Beaches Link and Gore Hill Freeway Connection

Response to DPIE - Independent reviewer comments:
Traffic and transport

TO: Department of Planning, Industry and Environment
FROM: Transport for NSW
DATE: 13 April 2021
REV: Rev.2

Figure 5-1 Overview of the Beaches Link and Gore Hill Freeway Connection project (map 1)

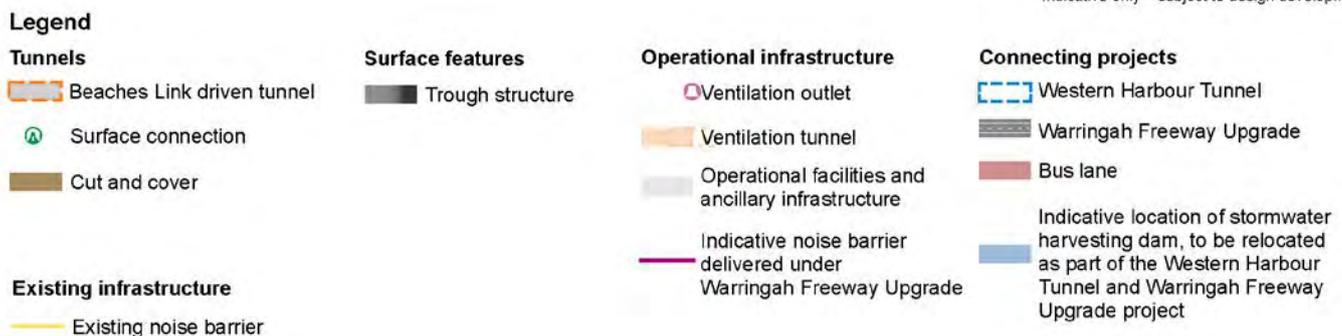
Row #	Issue location	Issue raised by DPIE independent reviewer	Transport for NSW response
1	1. Introduction		
2	1.1 Background	None	N/A
3	1.2 Scope and limitations	None	N/A
4	1.3 SEARs	None	N/A
5	2. Project need and alternatives		
6	2.1 Review of the project need	None	N/A
7	2.2 Review of the Options Analysis	None	N/A
8	3. Project description detail		
9	3.1 General	None	N/A
10	3.2 Interface Area: Warringah Freeway and Surrounds	<p>The interface area design is clearly presented and well explained. However, there is no detail showing the bus priority works proposed at the interface area to join into the southbound bus lane included in the WHT-WFU project. This should be marked or at least noted on Figure 5-1 or provided separately to show how this transition is proposed to occur.</p> <p>Figure 5-1 should be updated in the RtS to show how bus priority works with the</p>	<p>As outlined in Table 5-9 of Chapter 5 (Project description) of the EIS, buses travelling southbound in the Beaches Link tunnel would be provided with direct access to a new southbound bus lane on the Warringah Freeway.</p> <p>Figure 5-1 of Chapter 5 (Project description) has been updated to show the bus lane included in the Warringah Freeway Upgrade (refer to Attachment A) and will be included as a clarification in the submissions report. The transition for buses moving from the Beaches Link tunnel southbound general traffic lanes into the bus lane would occur on the surface of the Warringah Freeway, roughly in the area between Ernest Street and Falcon Street.</p>

*Further detail added to depict southbound bus lane on the Warringah Freeway

Figure 5-2 Overview of the Beaches Link and Gore Hill Freeway Connection project (map 2)

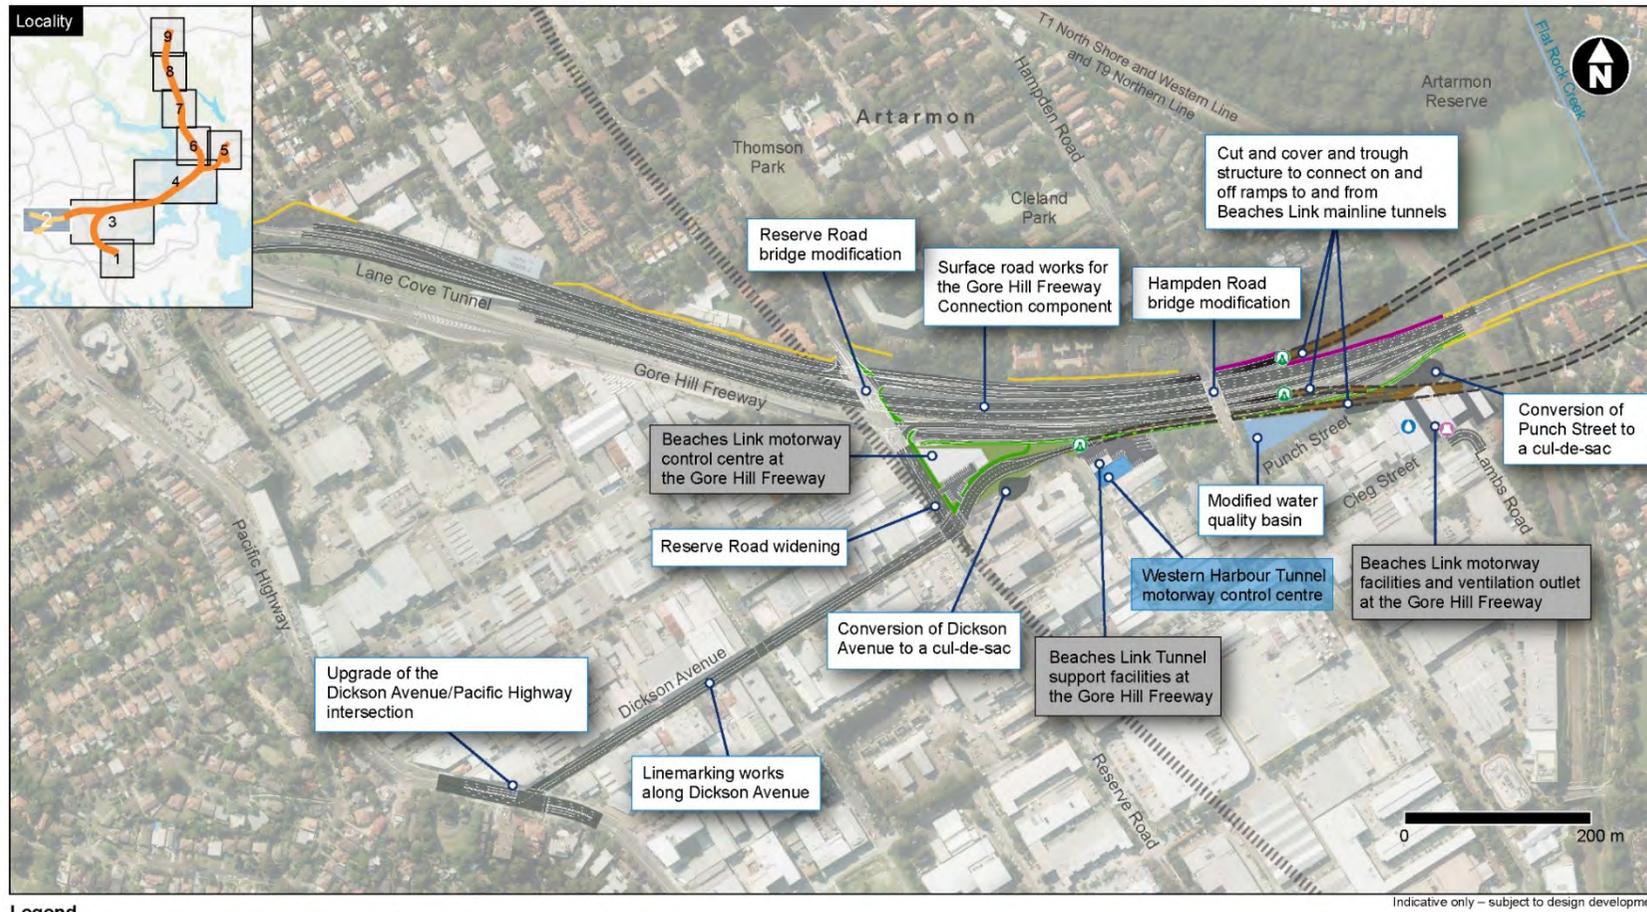
Row #	Issue location	Issue raised by DPIE independent reviewer	Transport for NSW response
		southbound bus lane included in the WHT-WFU project.	
11	3.3 Interface Area: Gore Hill Freeway and Artarmon	<p>This area is generally well presented and clear. However, it is not clear in Chapter 5 of the EIS if Dickson Avenue is proposed to be converted to one-way westbound which is what Figure 5-2 suggests. This figure also suggests that Dickson Avenue will be reduced to a single traffic lane with parking lanes either side between Clarendon Street and Reserve Road. The figure also suggests that Curry Lane is converted from one-way westbound to one-way eastbound.</p> <p>The RtS should clarify the configuration changes associated with Dickson Avenue, Curry Lane and Carlotta Street and describe the impacts of these changes.</p>	<p>Surface road works associated with the Gore Hill Freeway Connection component are summarised in Table 5-12 and shown in Figure 5-2 and Figure 5-29. In terms of changes to Dickson Avenue, this includes:</p> <ul style="list-style-type: none"> • Removal of the connection between Dickson Avenue east and Reserve Road, Artarmon, with conversion of Dickson Avenue to the east of Reserve Road to a cul-de-sac • Modifications to the Dickson Avenue west/Reserve Road intersection to accommodate the new Beaches Link off ramp • Upgrade and inclusion of traffic lights at the Dickson Avenue/Pacific Highway intersection and centre linemarking along Dickson Avenue west of Reserve Road. <p>To confirm, changes to Dickson Avenue will not include reducing Dickson Avenue to a single lane/ one way traffic.</p> <p>No configuration changes are proposed for Curry Lane and Carlotta Street.</p> <p>Figure 5-2 of the EIS has been updated accordingly to better represent line marking on Dickson Avenue (refer to Attachment B) and will be included as a clarification in the submissions report.</p>

60	6.4 Interface Area: Gore Hill Freeway and Artarmon	The changes to Dickson Avenue west of Reserve Road are unclear but it seems that the eastern end of Dickson Avenue at Reserve Road is to be converted to one-way westbound (which should be confirmed). Presumably, this has been done to remove	Refer to response to row #11 – changes to Dickson Avenue will not include reducing Dickson Avenue to single lane/ one way traffic or any configuration changes for Curry Land and Carlotta Street. Figure 5-2 of the EIS has been updated to provide additional clarity with respect to this configuration (refer to Attachment B) and will be included as a clarification in the submissions report.

*Further detail added to depict eastbound and westbound traffic lanes on Dickson Avenue, west of Reserve Road.
